Stirling City Centre

I have visit the open day at Saturday 20th September 2008 at Stirling Civic Centre and would like to make the following commends to the Stirling City Centre Alliance Survey:

Figure 5 Streets & Cars dominating the area

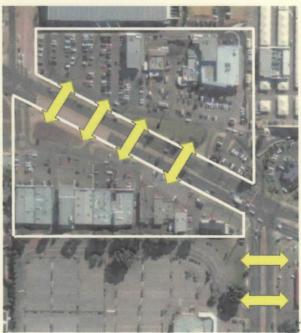
Also in my opinion there is too much emphasis placed on cars (see figure 5). If private car ownership is bound to decline as seems likely with the decline of oil as fossil fuel and the likely increase in petrol price a different approach to this development is needed.
